UNITED STATES
DEPARTMENT OF THE INTERIOR
BUREAU OF LAND MANAGEMENTFORM APPROVED OMB
No. 1004-0137 Expires:
December 31, 2024**SUNDRY NOTICES AND REPORTS ON WELLS**
**Do not use this form for proposals to drill or to re-enter an
abandoned well. Use Form 3160-3 (APD) for such proposals.**

Drickey Queen Sand Unit 036

P&A Procedure
Acacia Operating Company, LLC
Drickey Queen Sand Unit #36
API: 30-005-01036

**Drickey Queen Sand Unit 36
30-005-01036
Acacia Operating Company, LLC
October 17, 2025
Conditions of Approval**

Proposed
Wellbore Diagram

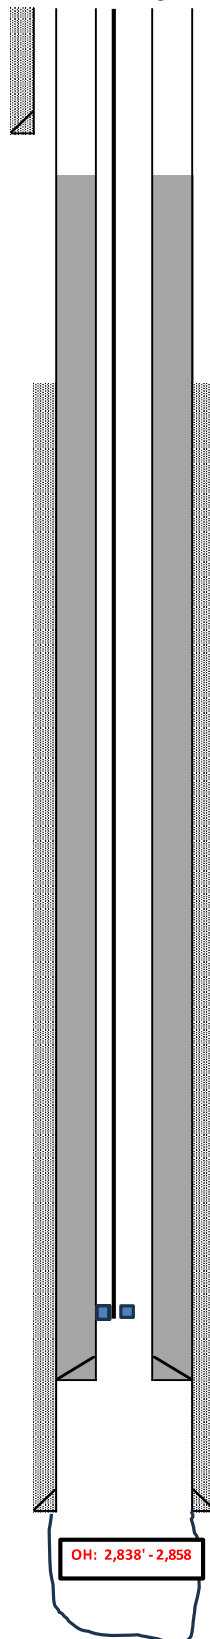
1. Operator shall place a balanced Class C cement plug from **2,908'**-2,657' to seal the top of the liner. WOC and TAG.
2. Operator shall place a balanced Class C plug from 2,172' to **1,869'** to seal the top of the Yates and base of Salt. WOC and TAG.
3. Operator shall perf at 1,402' and squeeze class C cement to **1,868'** to seal the base of Salt. WOC and TAG.
4. Operator perf at 1,402' and squeeze Class C Cement to **1,130'** to seal the top of Salt and Rustler.
5. Operator shall perf at 100' and squeeze cement class C cement to surface.
6. Dry hole marker must be below ground.
7. Surface reclamation will need to be completed once the well bore has been plugged. Please contact rflores@blm.gov for additional information.
8. See Attached for general plugging stipulations.
